PG&E Letter DCL-14-076

Docket No. 50-275, OL-DPR-80
Docket No. 50-323, OL-DPR-82
Diablo Canyon Units 1 and 2
Pacific Gas and Electric Company's Third Six-Month Status Report in Response to
March 12, 2012, Commission Order Modifying Licenses with Regard to
Requirements for Mitigation Strategies for Beyond-Design-Basis External Events
(Order Number EA-12-049)

**Pacific Gas and Electric Company's Third Six-Month Status Report for the
 Implementation of NRC Order EA-12-049**

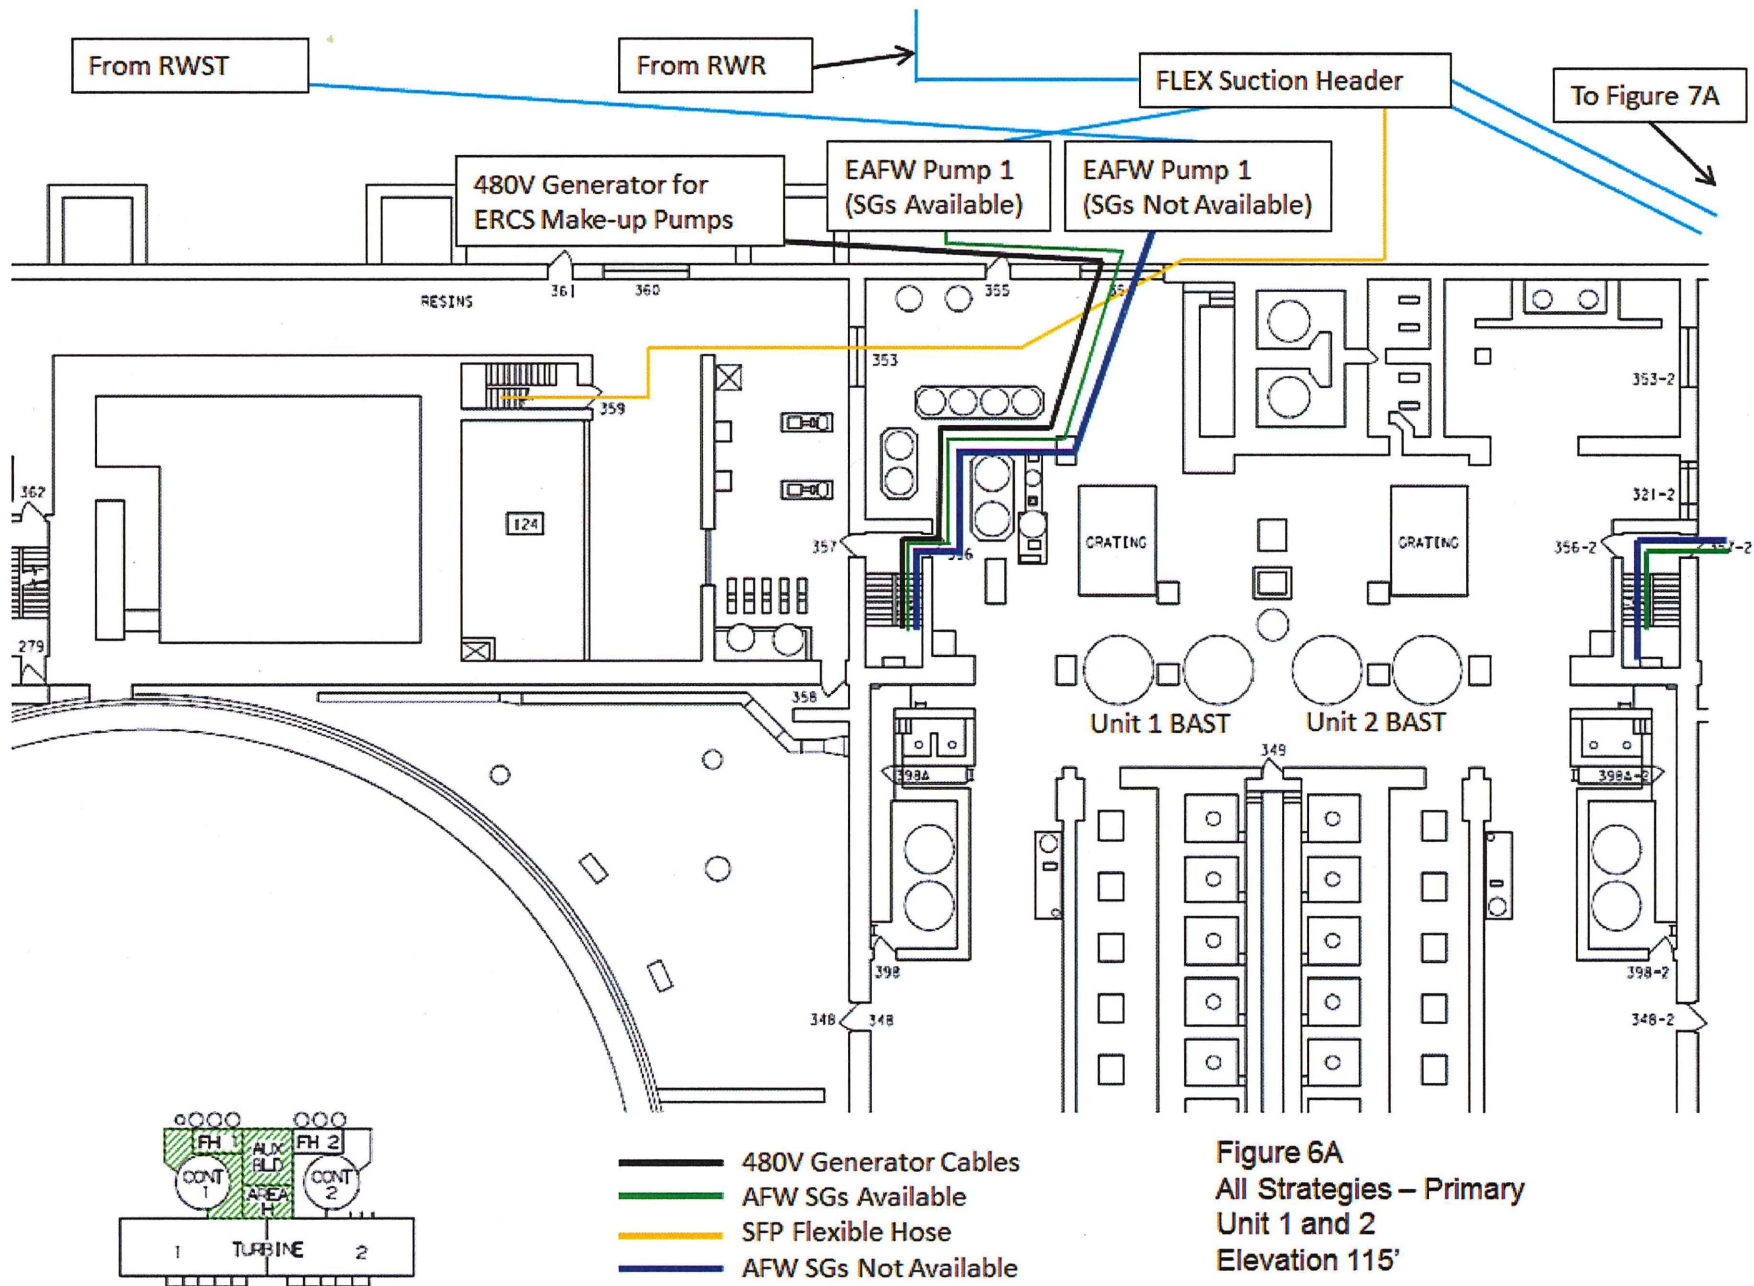
- (1) Figure 6A Revisions:
 - (a) Removed the ESFP pump from the SFP hose line.
 - (b) Clarified the legend to state “SFP Flexible Hose.”
 - (c) Modified route for the SFP flexible hose to be routed up the stairs to the SFP.

- (f) Modified route for 480-V generator cables to be routed down the stairwell for the ERCS make-up pumps.
 - (g) Updated the legend to include route for 480-V generator cables for powering the ERCS make-up pumps.

- (h) Updated the legend to remove reference to “RCS SGs Available.”
 - (i) Clarified “To Unit 2” to “To Figure 7A.”
- (2) Figure 6B Revisions:
 - (a) Added staging location for the Unit 1 ERCS make-up pump.

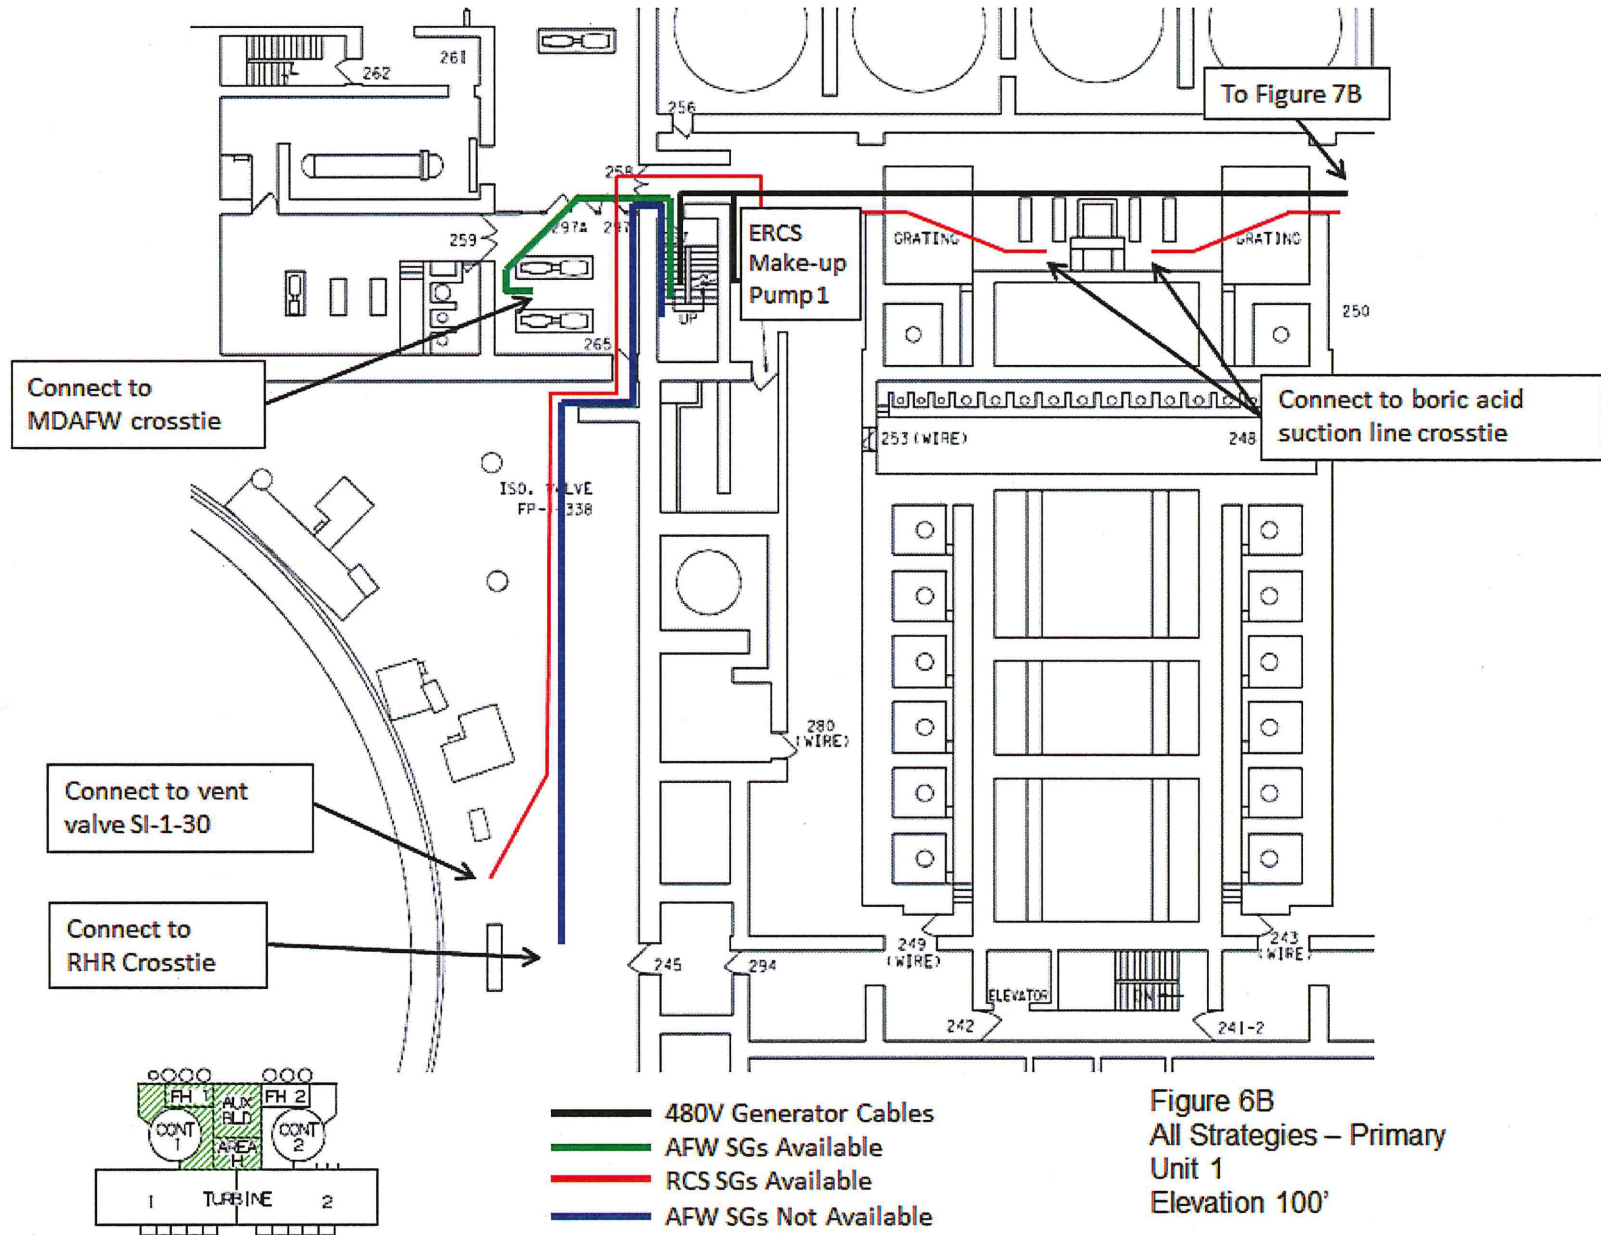
- (b) Added route for 480-V generator cables to the ERCS make-up pumps.
 - (c) Updated the legend to include route for 480-V generator cables for powering the ERCS make-up pumps.

- (e) Added note "To Figure 7B" for lines that connect to the Unit 2 ERCS make-up pump.
- (3) Figure 7A Revisions:
- (a) Removed the ESFP pump from the SFP hose line.

Figure 7A
 All Strategies – Primary
 Unit 2
 Elevation 115'

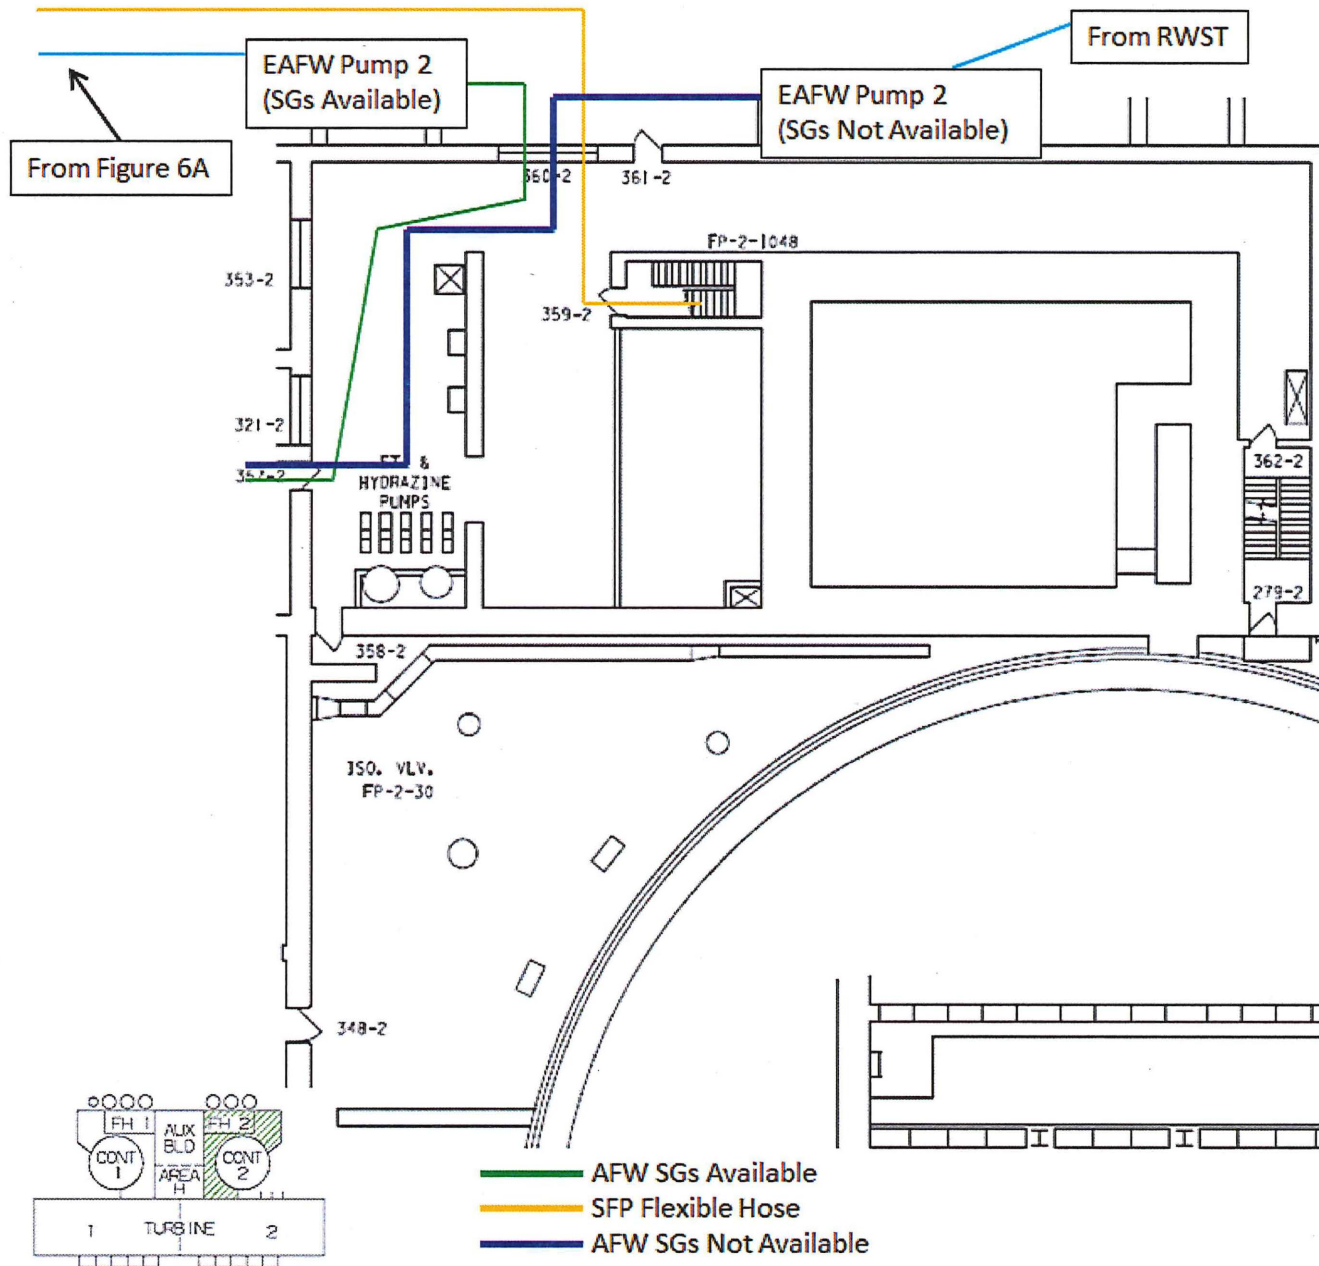
- (b) Clarified the legend to state "SFP Flexible Hose."
 - (c) Modified route for the SFP flexible hose to be routed up the stairs to the SFP.
 - (d) Updated the legend to remove reference to "RCS SGs Available."

- (e) Clarified "From Unit 1" to "From Figure 6A."
- (4) Figure 7B Revisions:
- (a) Added staging location for the Unit 2 ERCS make-up pump.
 - (b) Added route for 480-V generator cable to the ERCS make-up pump.

Figure 7B
 All Strategies – Primary
 Unit 2
 Elevation 100'

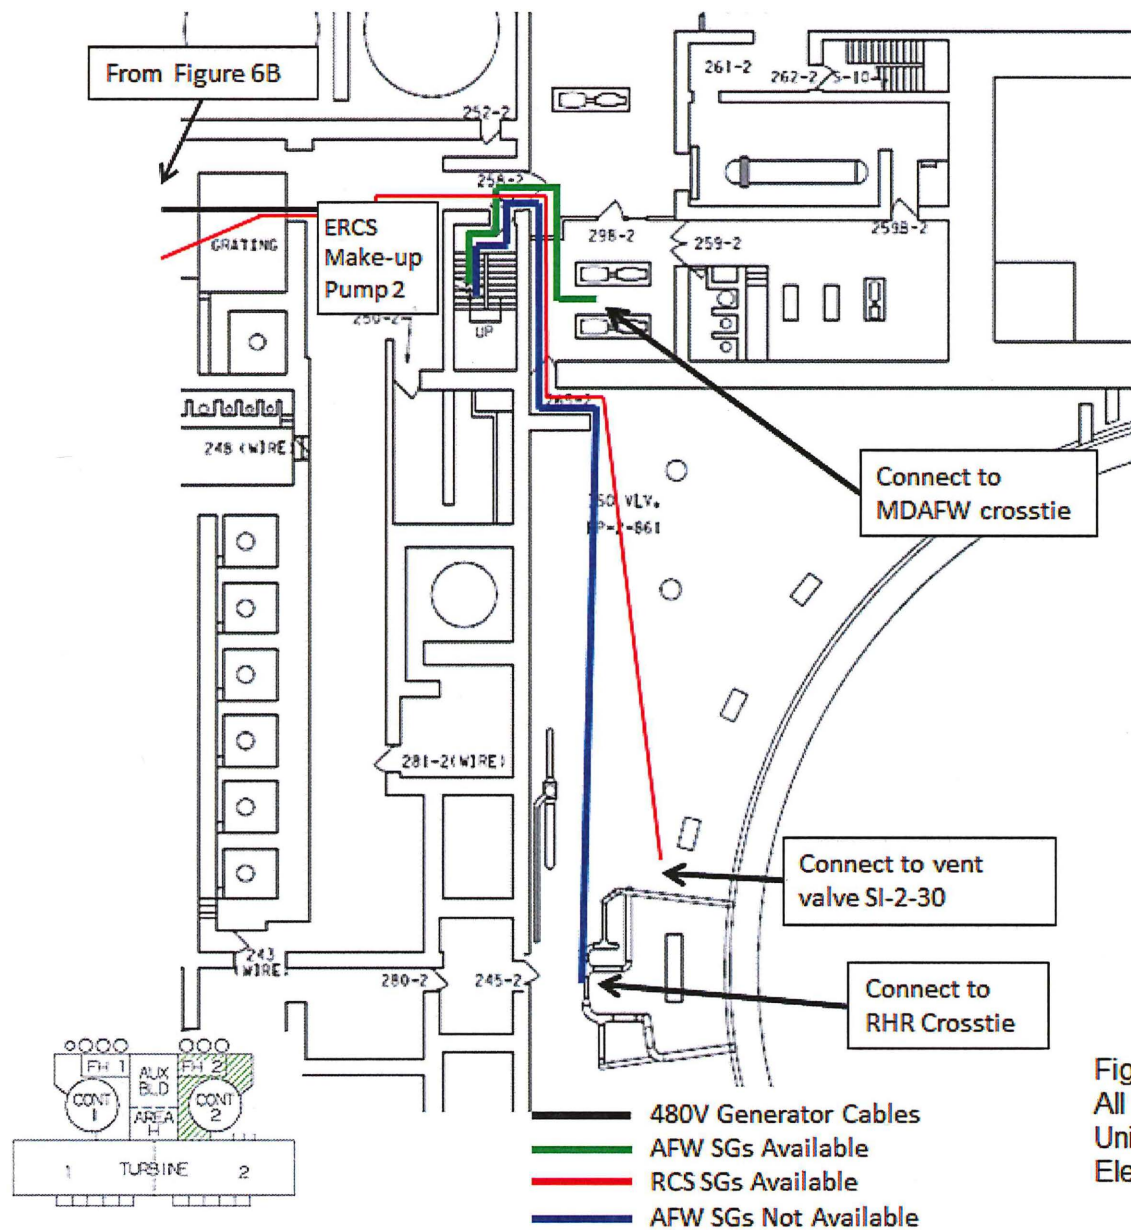
- (e) Added note "To Figure 6B" for lines that connect from the Unit 2 ERCS make-up pump.
- (5) Figure 8A Revisions:
- (a) Removed the ESFP pump from the SFP hose line.

Figure 8A
 All Strategies – Alternate
 Units 1 and 2
 Elevation 115'

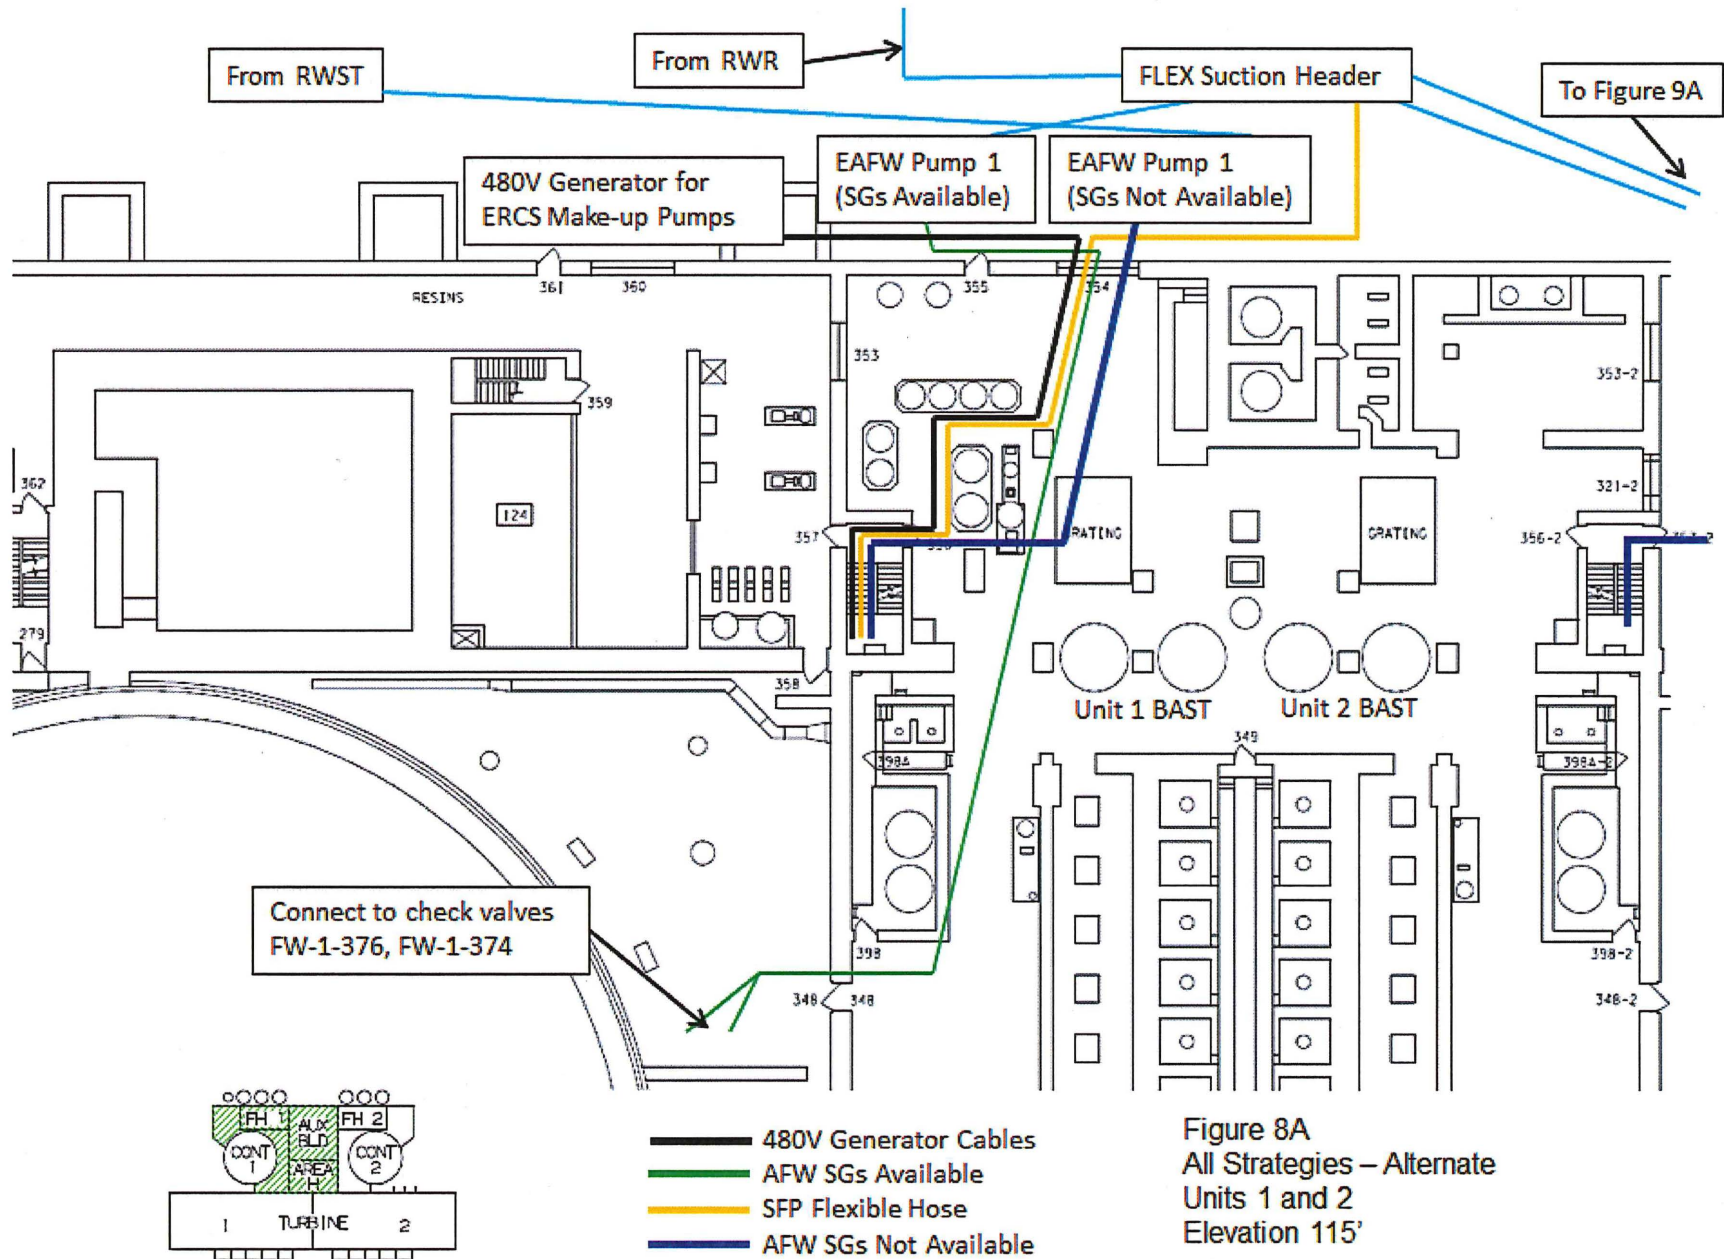
- (d) Removed the staging location for the ERCS make-up pumps from the 115-foot elevation (now on the 100-foot elevation).
 - (e) Modified route for 480-V generator cables to be routed down the stairwell for the ERCS make-up pumps.

- (f) Updated the legend to include route for 480-V generator cables for powering the ERCS make-up pumps.
 - (g) Updated the legend to remove reference to "RCS SGs Available."

- (h) Clarified "To Unit 2" to "To Figure 9A."
- (6) Figure 8B Revisions:
- (a) Added staging location for the Unit 1 ERCS make-up pump.
 - (b) Added route for 480-V generator cables to the ERCS make-up pumps.
